Work Order ID 98943

Item Name: Replacement Skidtube

| DRAWING NO. D2650 | TITLE 206/407 SKIDTUBE ASSEMBLIES | REV. F | DART AEROSPACE LTD ENGINEERING ORDER | | D.E.O. NO. D2650-F-1 | SHEET NO. SHEET 1 OF 1 | SCALE NTS |

CHANGE C'BORED WELDED CROSSBOLT SPACERS TO SWAGED SPACERS

DETAIL B

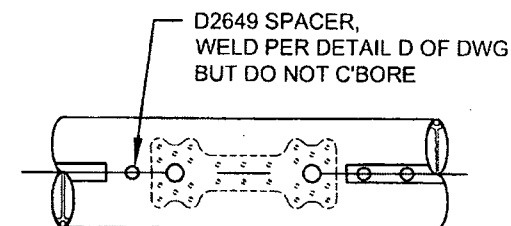
C'BORED HOLES ARE **NOW SWAGED** PER DETAIL G BELOW. FOR THE Ø0.375 HOLE THAT IS NOT C'BORED, WELD PER DETAIL D OF DWG (SEE AMENDED DETAIL B FOR REFERENCE).

AMENDMENT TO DETAIL B
NOT TO SCALE

DETAIL G

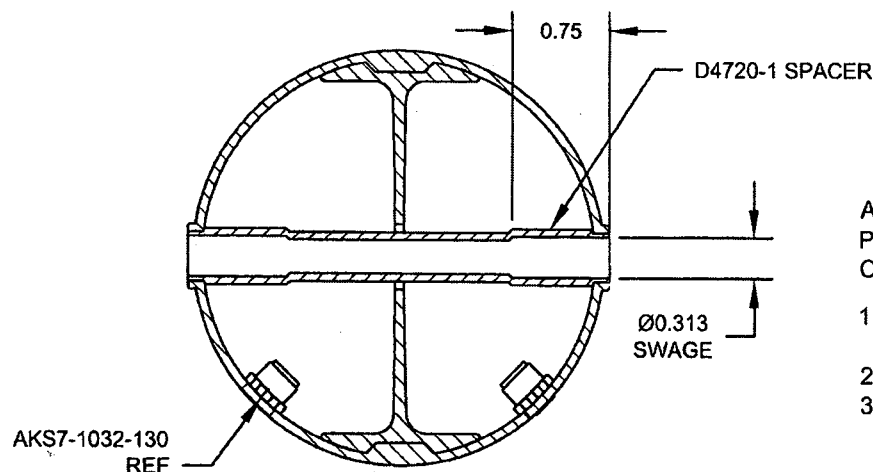
ADD DETAIL G BELOW, WHICH IS THE SAME SECTION VIEW AS DETAIL D OF DWG.
